SUBJECT: Forwards Relief Request 96-02, requesting relief from ASME Section XI 1989 edition to allow util to take credit for limited ultrasonic exams on SG primary side tubesheet-to-head welds.

Subject: Duke Power Company
Oconee Nuclear Station, Units 1, 2, and 3
Docket Nos. 50-269, -270, and -287
Third Ten Year Inservice Inspection Interval
Request for Relief No. 96-02

10-YEAR INTERVAL REQUEST FOR RELIEF NO. 96-02

(INLET)
B03.150.001

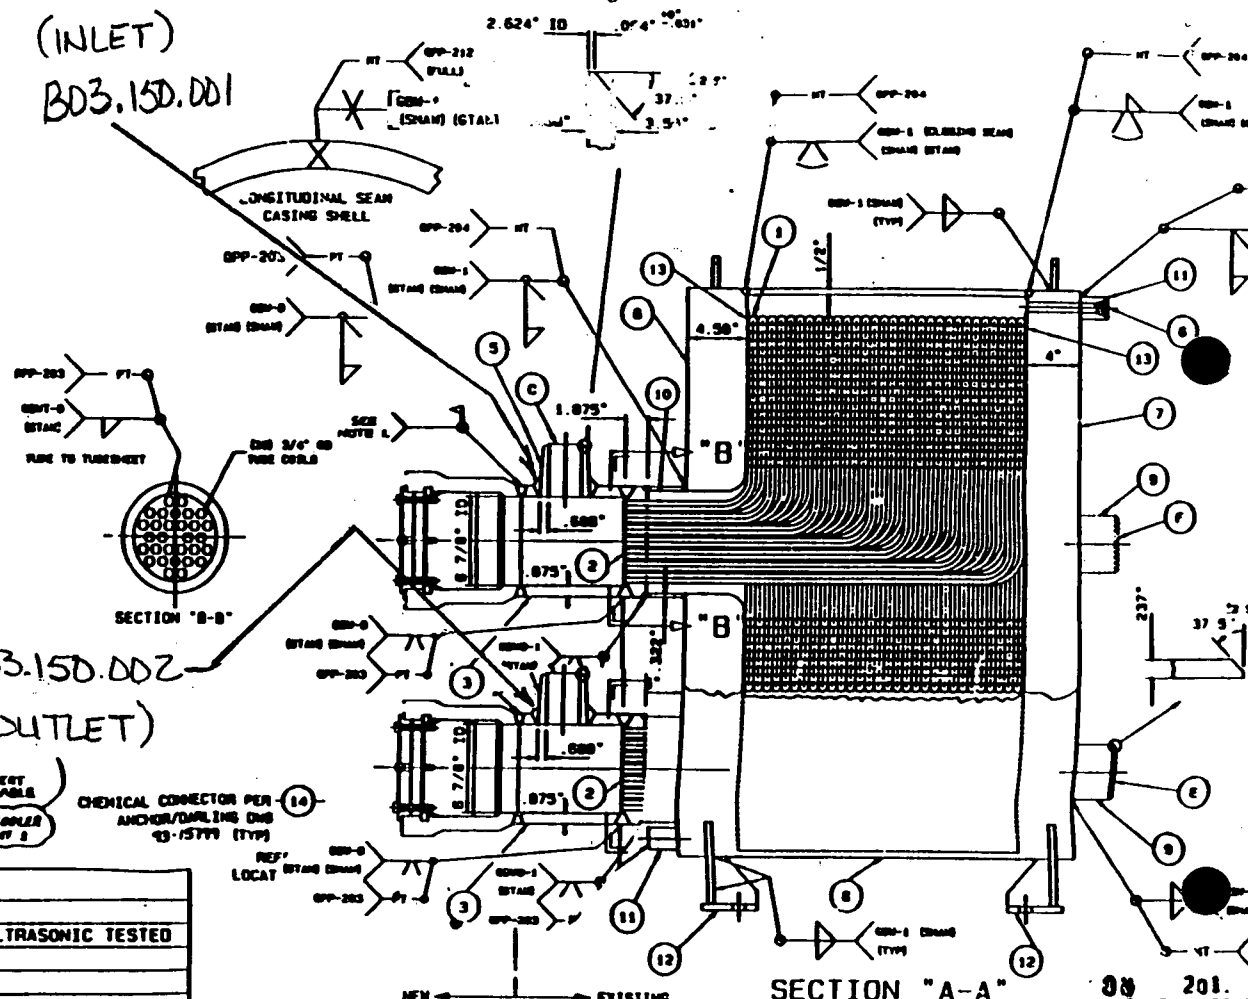
Weld 2-LDCA-INLET-V1 is limited to 26.96% coverage of the required volume because of branch connection interference.

Weld 2-LDCA-OUTLET-V2 is limited to 26.96% coverage of the required volume because of branch connection interference.
